## **SIGHT PORT FAILURES ON COMBUSTION CHAMBERS IN SPENT ACID REGENERATION (SAR) FACILITIES**

Findings following an operational failure of several site glass ports on combustion chambers at operating spent acid regeneration (SAR) plants established the root cause as over-heating of the combustion/decomposition vessel. The sight port nozzle is particularly sensitive to the combination of internal refractory and external insulation. If external insulation is excessive and/or internal refractory is minimal the result is overheating of the metal surface of the combustion chamber/decomposition furnace. Failure of the site ports and surrounding metal shell can result. Collateral damage to the refractory can further damage the metal shell.

SIGHT PORT DIMENSIONAL DETAIL

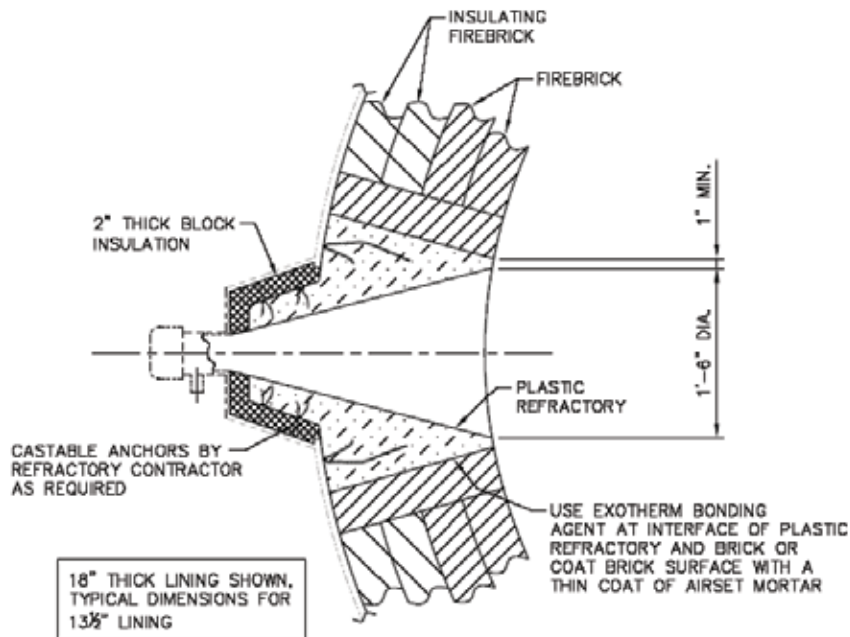
To further reduce the risk of overheating the combustion chamber shell, MECS has re-designed the sight glass detail and associated refractory lining. Sketches attached highlight those changes. These details will yield a more robust site port design that is less likely to overheat during operation.
